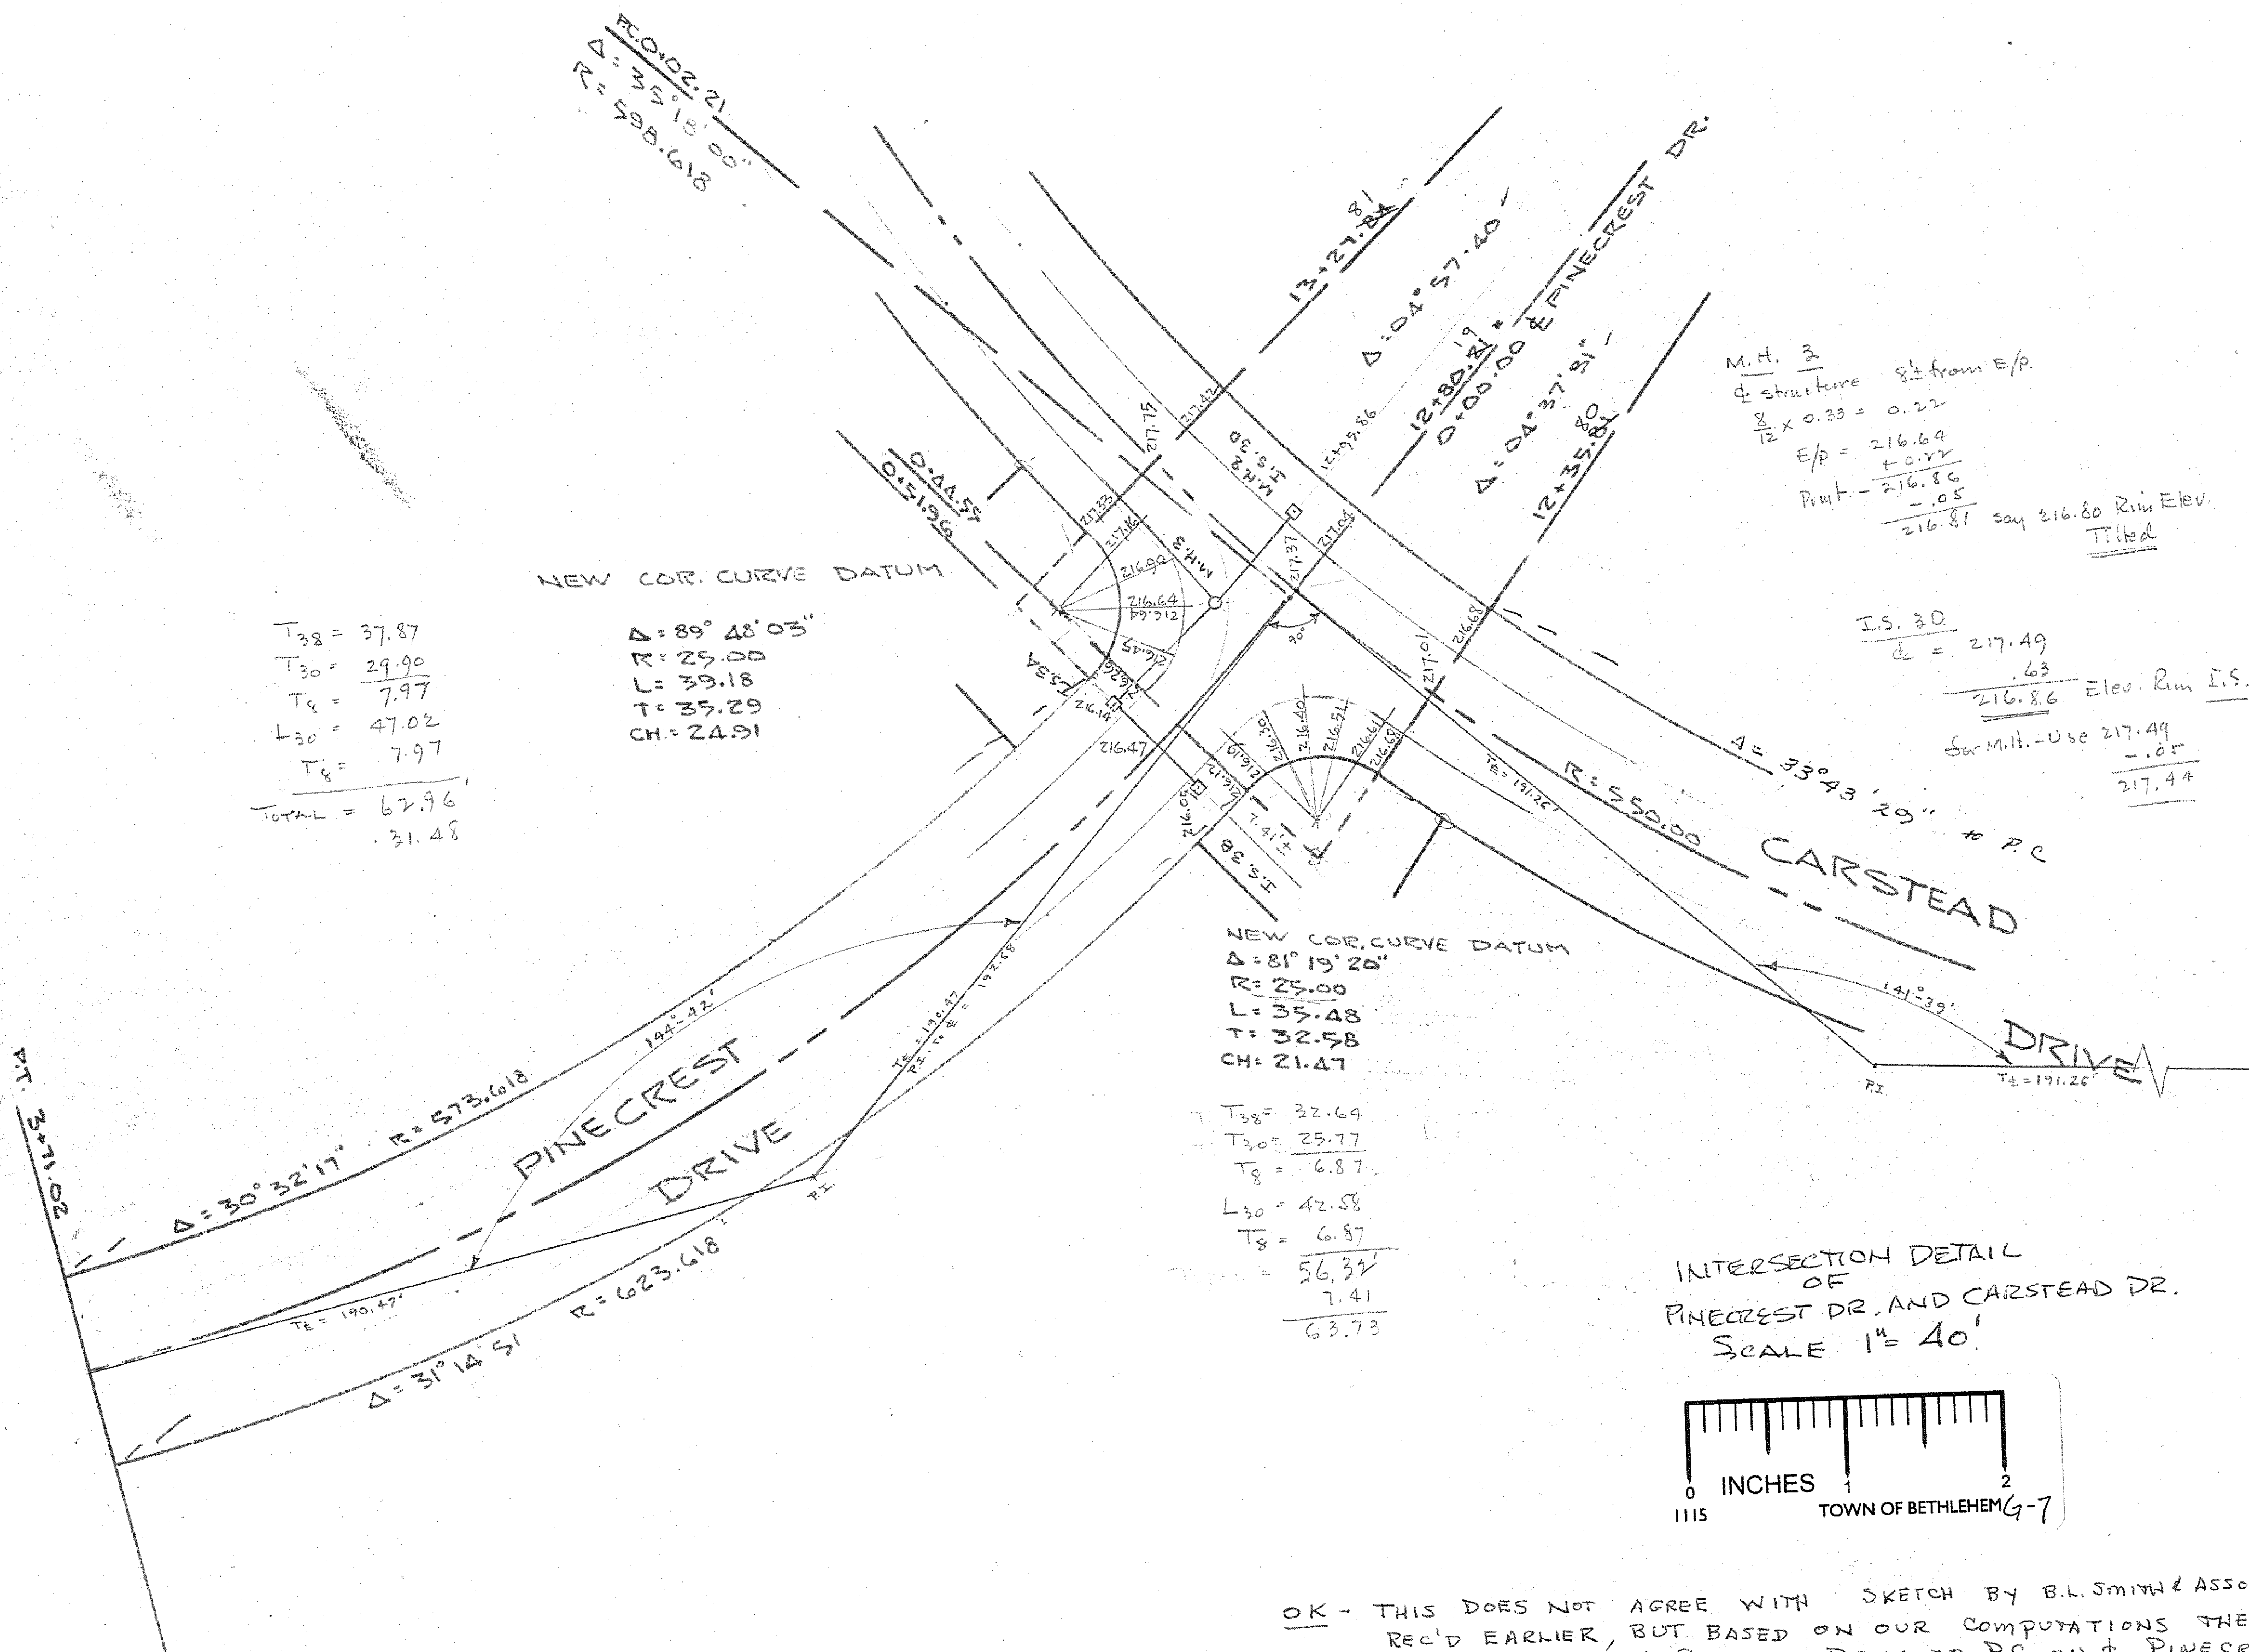
OK - THIS DOES NOT AGREE WITH SKETCH BY B.H. SMITH & ASSOCIATES
 REC'D EARLIER, BUT BASED ON OUR COMPUTATIONS THE TANGENT
 DISTANCE FROM R CARSTEAD DRIVE TO P.C. ON PINECREST IS
 2.208'. THIS AGREES WITH BOUTELLE'S WORK AS SHOWN ON
 THIS SHEET. THUS IGNORE THE 2.46' DISTANCE SHOWN ON
 B.H. SMITH SKETCH & USE THIS INFORMATION.
